Applicant:	)	Group Art Unit: 2901
	)	
ANTHONY MAGLICA	)	Examiner: M. Tung
	)	
Serial No. 07/411,576	)	
	)	
Filed: September 22, 1989	)	
	)	
For: MINIATURE FLASHLIGHT	)

SUBSTITUTE SECOND AMENDMENT AFTER FINAL REJECTION

**Fig. 1**

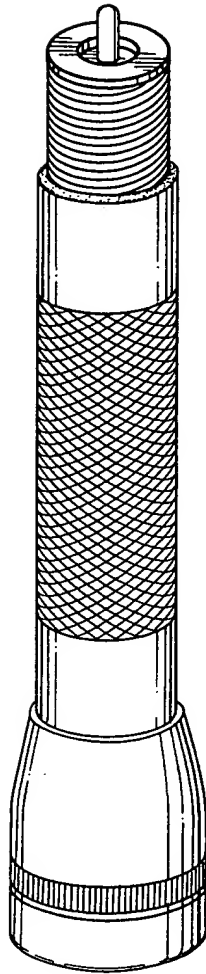
Applicant is intending to reduce as many issues as possible to leave the single issue of the shape of the flashlight head, i.e., curved versus angled. The diameters of the added rings in Figures 3 and 4 reflect the shapes in Figures 1 and 2. Further, the threads have been appropriately oriented. Consequently, the drawings are believed to be acceptable with the exception of the head portion as mentioned above.
